Project	<b>IEEE 802.16 Broadband Wireless Access Working Group</b> < <a href="http://ieee802.org/16">http://ieee802.org/16</a> >		
Title	<b>Supplementary Text for LB #11 comments</b>		
Date Submitted			
Source(s)	Naftali Chayat	Voice: +972-36457834	Fax: +972-36456290
		mailto: <a href="mailto:vladimir.yanover@alvarion.com">vladimir.yanover@alvarion.com</a>	
	Tal Kaitz	Voice: +972-36456273	
		mailto: <a href="mailto:tal.kaitz@alvarion.com">tal.kaitz@alvarion.com</a>	
	All with		
	Alvarion Ltd.		
	21 A Habarzel St. Ramat - Hahayal		
	Tel - Aviv 69710		
Re:			
Abstract			
Purpose			
Notice	This document has been prepared to assist IEEE 802.16. It is offered as a basis for discussion and is not binding on the contributing individual(s) or organization(s). The material in this document is subject to change in form and content after further study. The contributor(s) reserve(s) the right to add, amend or withdraw material contained

# Supplementary Text for LB#11 comments

Figure 1: Spectral Masks for BW=10MHz

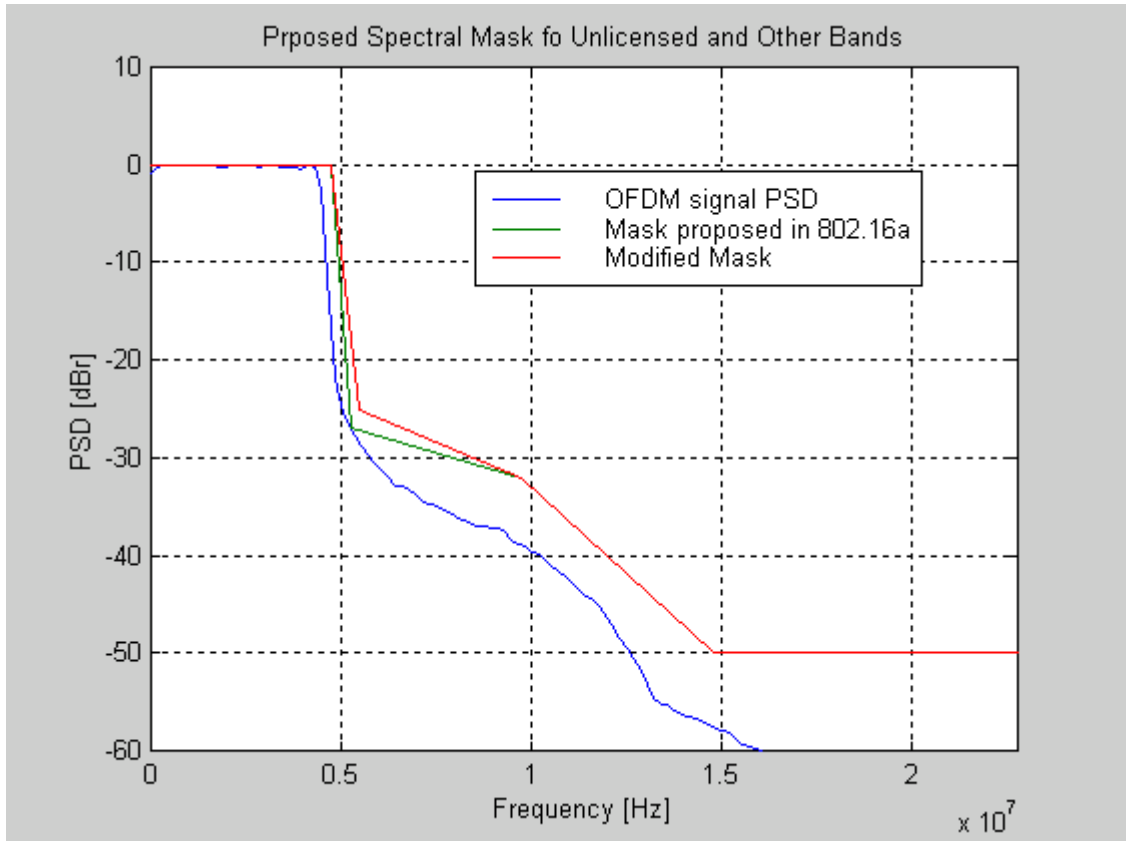
Current spectral masks for OFDM are impractical in that a single corner point determines the operating backoff, and does not allow the utilization of most of the mask region.

The proposed masks are similar to those of IEEE802.16a section 8.6.2. The masks are scaled to support other bandwidths. We propose to modify the mask of 802.16a around point B (5.25MHz @ BW=10MHz). This is to allow the relaxation of the spectral requirements, as demonstrated below.

In Figure the spectrum of an OFDM waveform with BW=10MHz is shown vs. the current and the proposed spectral masks. The OFDM signal is distorted by a power amplifier (Rapp model p=2) with an input back-off of 8dB. It can be seen the inter-modulation skirts violate the current 802.16a mask, around 5MHz. The modification prevents the violation.

Table XXX mask for unlicensed bands

Point	A	B	C	D
Frequency	0.95*BW	1.09*BW	1.95*BW	2.95*BW
Amplitude	0dB	-25dB	-32dB	-50dB
